**NYS DOT Champlain Hudson Power Express ("CHPE")
Environmental Management & Construction Plan
Notice of Major Change**

Project: Champlain Hudson Power Express

Segment: 8

Notice Number: 141

PERMIT DRAWING NO. **N/A**
 DRAWING NO. **C-105**

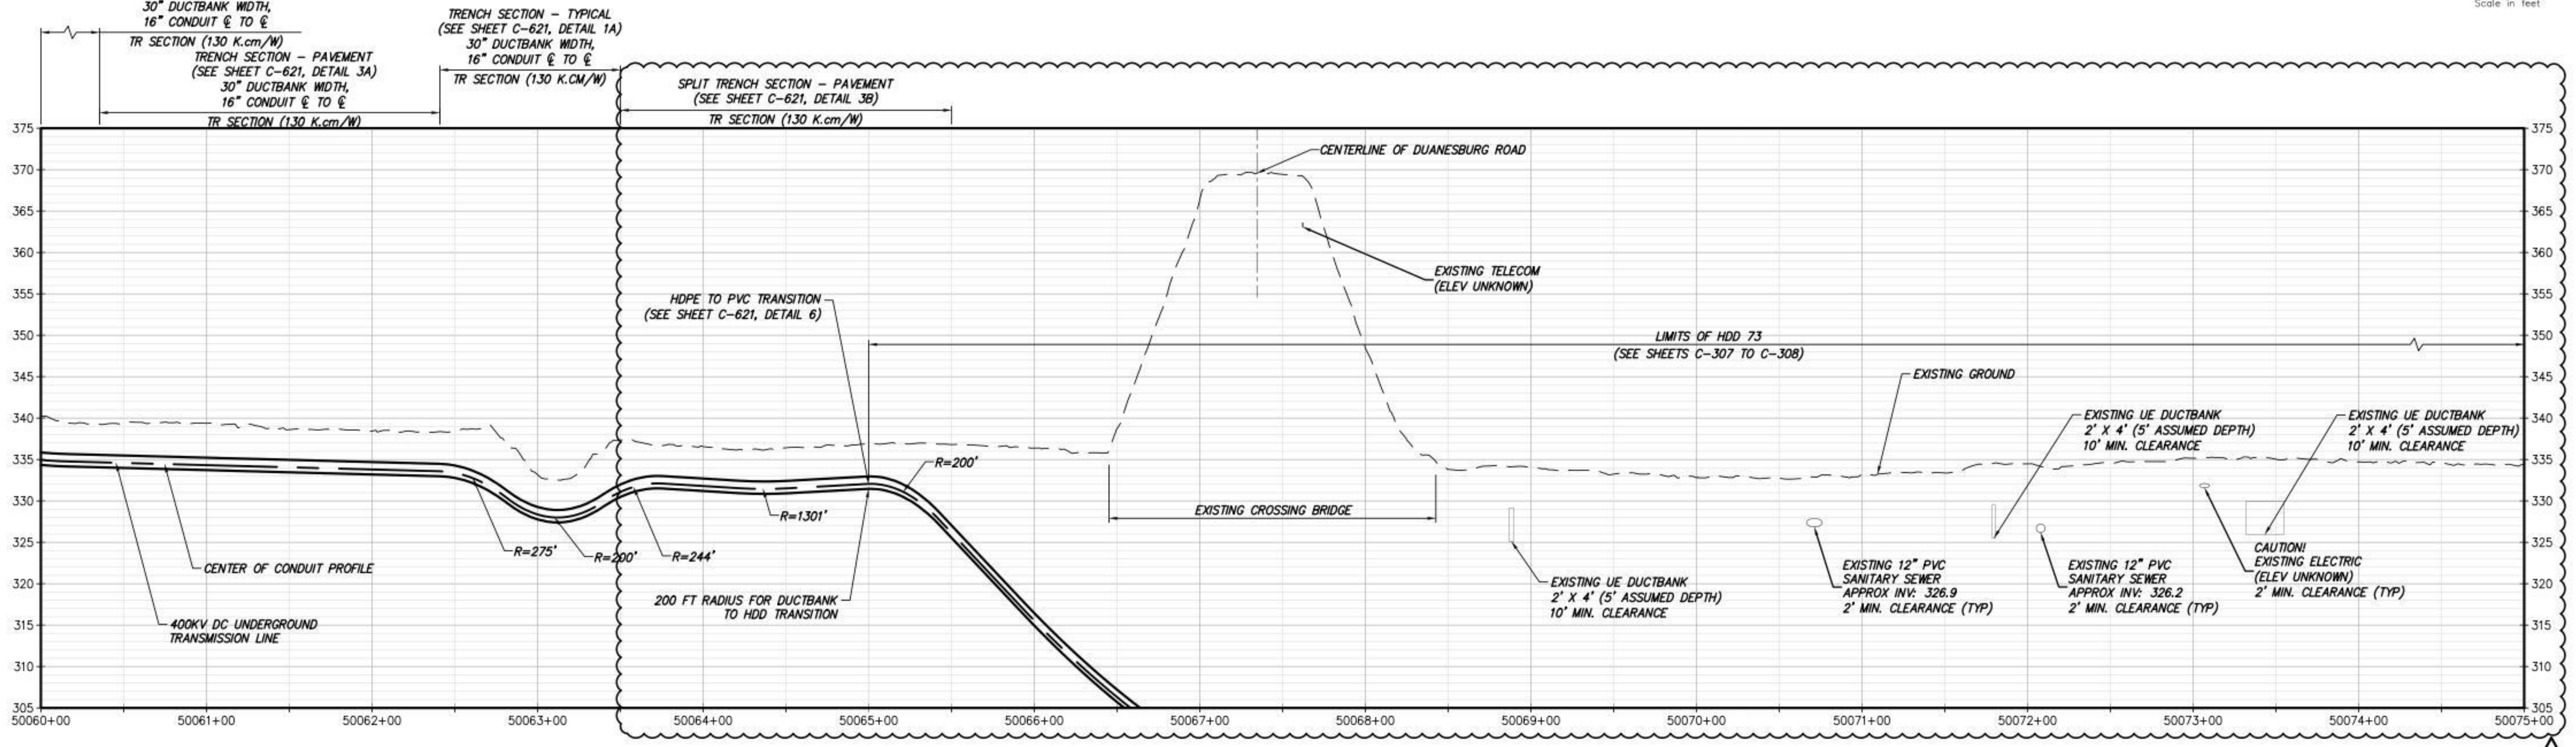
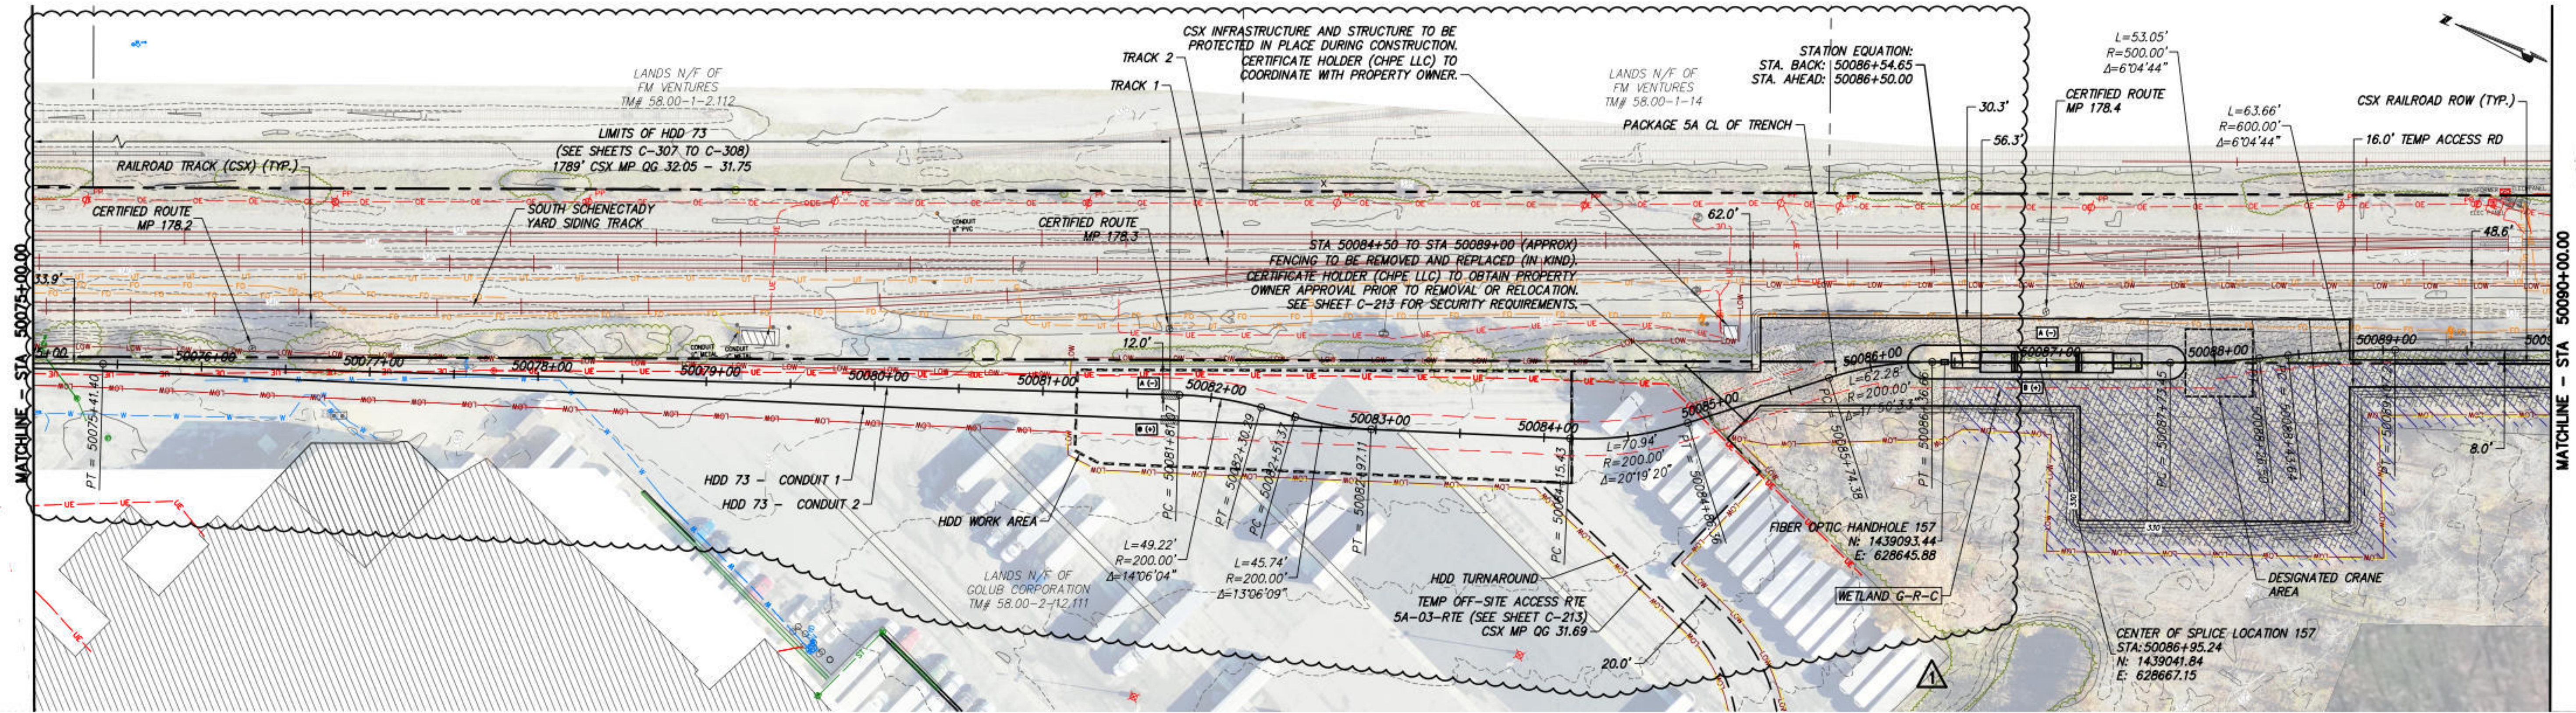
Sheet No.	Rev No.	Revision Description	Summary
G-001	2	NDC-0049: HDD 73 Extension on Golub Property	Added sheets C213.1, C-307.1, and C-308.1, revised sheet names for C-307 through C-308.1
C-105	1	NDC-0049: HDD 73 Extension on Golub Property	HDD 73 realigned for extension on Golub Corporation Property and to increase clearance from Duanesburg Road Bridge abutment. HDD 73 Work area revised (enlarged) to accommodate extension of HDD. HDD pits were relocated and offset to maintain required spacing. HDD profile added to sheet. The approximate Duanesburg Road Bridge Abutments were added in plan view along with clearance callouts consistent with NYSDOT coordination. Callouts were added for clearance to Golub Corporation Water Tank and utilities in profile.
C-106	1	NDC-0049: HDD 73 Extension on Golub Property	HDD 73 realigned for extension on Golub Corporation Property. HDD work area relocated from C-105 to C-106 based on coordination with Golub Corporation and CHPE LLC. Trench was realigned from new HDD pit locations up to Splice Location 157. Existing UE Ductbank on Golub Corporation Property added to plan view with required 10' min. clearance. Access revised accordingly.

PERMIT DRAWING NO. **N/A**
DRAWING NO. **C-106**

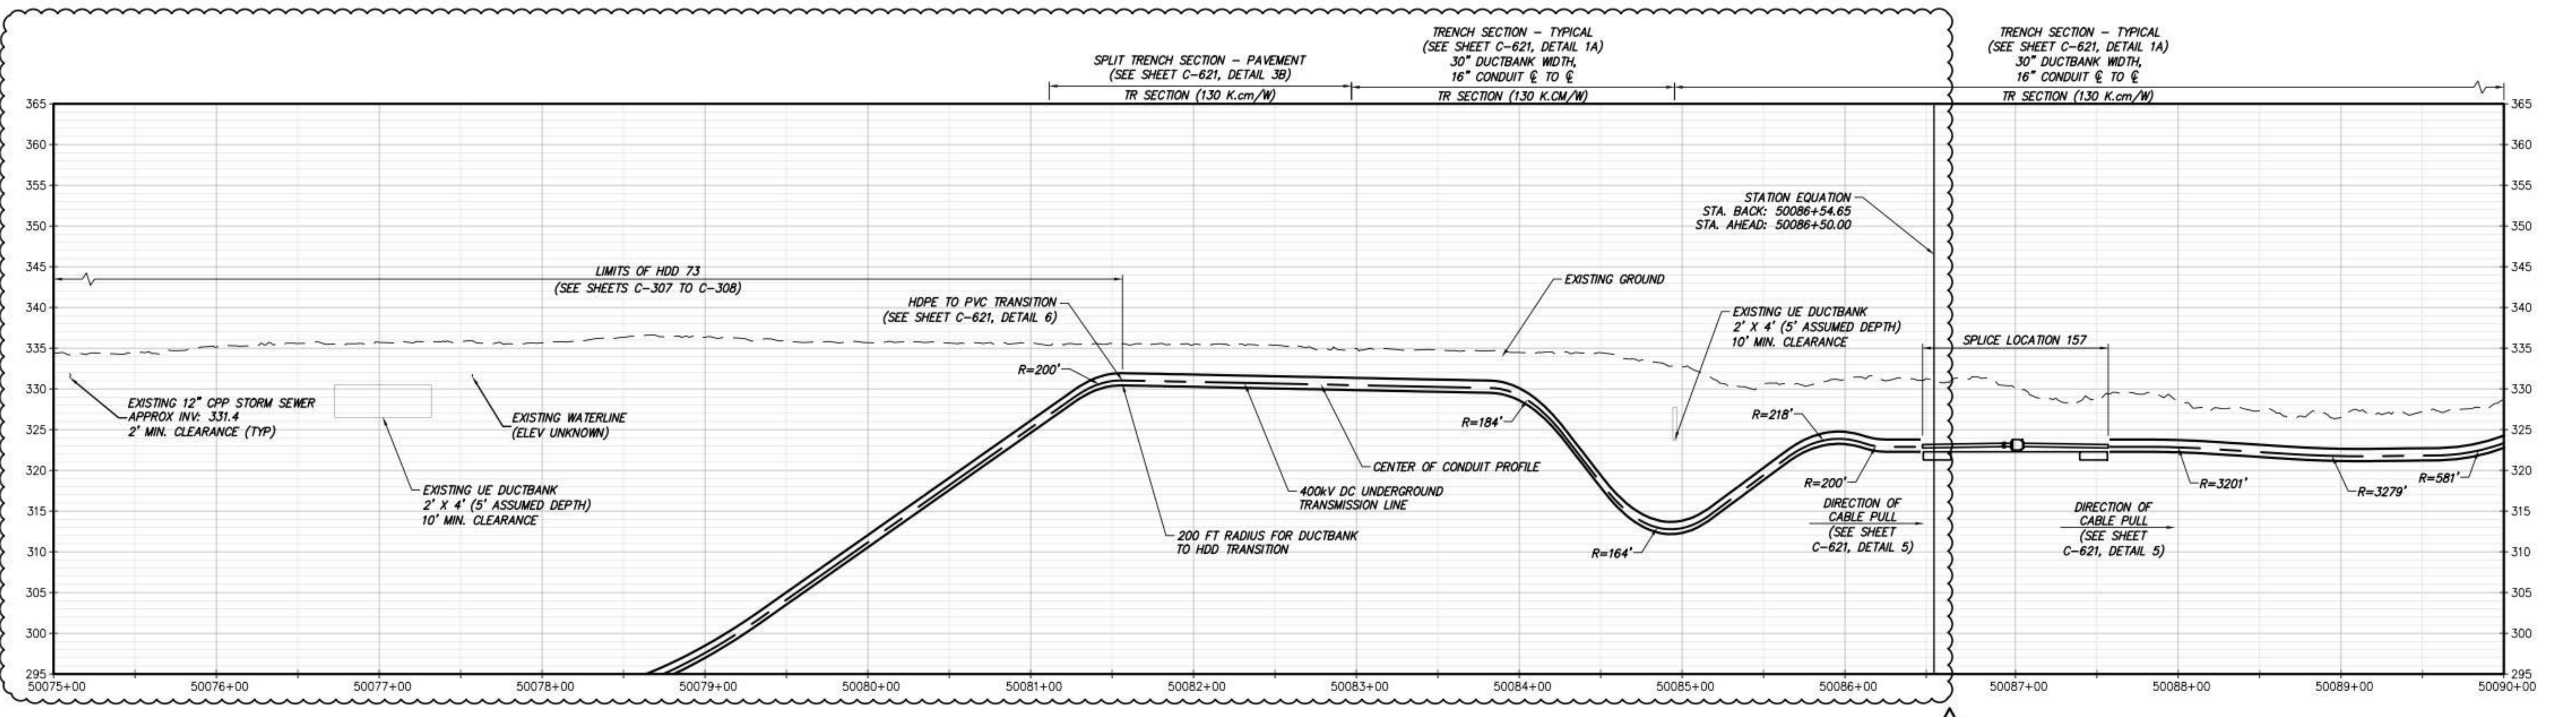
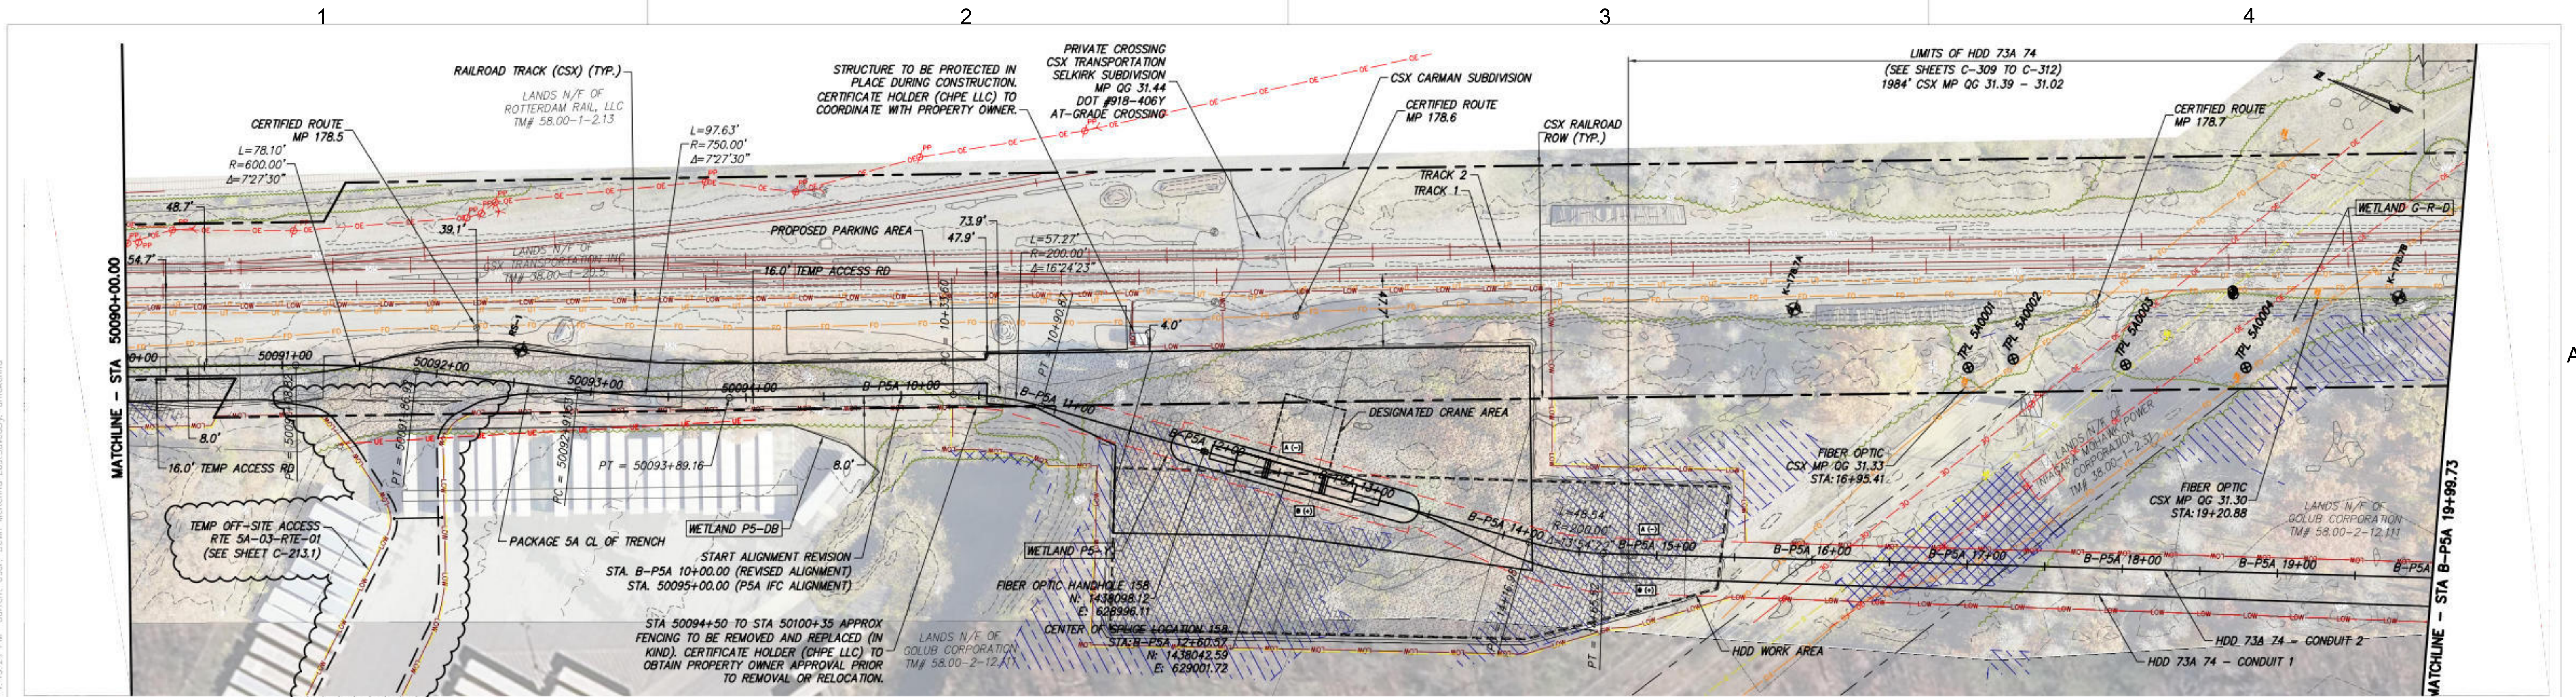
Excursion S8-2A is located within the Town of Rotterdam beginning about 130' S of Duanesburg Road Bridge Crossing of CSX tracks (approximately STA 50069 to 50086 on Sheet C-105 and C-106 of the Plan and Profile Drawings [Appendix C of the EM&CP]).
